Manual Valve

41750-03

Mitsubishi KM 4-Speeds

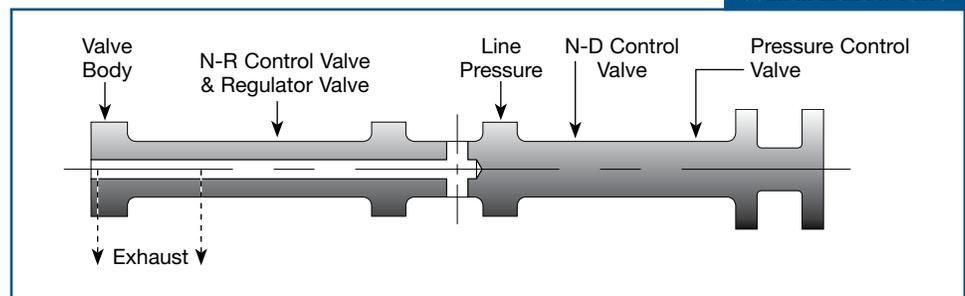
NOTE: Not recommended for some Hyundai applications. Do not use with .218" (5.5mm) ball in pump. Valve is calibrated to work with all units with .312" (8mm) ball in pump.

1. Remove OE manual valve from valve body and discard.
2. Replace with Sonnax manual valve.
